Service Info

Differing deflection pulleys

on tensioning unit assembly 534 0243 10 in petrol and diesel engines

Part no.: 534 0243 10

Image 2: Deflection pulley 532 0404 30 for vehicles with a petrol engine (left) and deflection pulley 532 0406 30 for vehicles with a diesel engine (right)

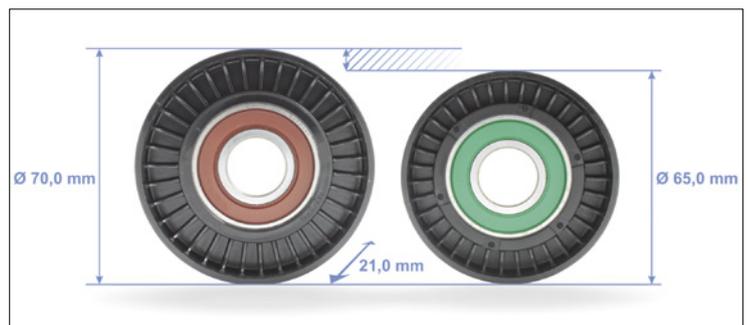
To use the assembly on the diesel engines listed above, the left deflection pulley 532 0404 30 must be replaced with deflection pulley 532 0406 30 (image 2).

Deflection pulley 532 0406 30 for diesel engines has a smaller diameter than deflection pulley 532 0404 30 (image 2).

The deflection pulley for diesel engines is not included in the assembly and must be ordered separately.

Ensure that the correct deflection pulley is fitted on the tensioning unit assembly before installing it in the vehicle!
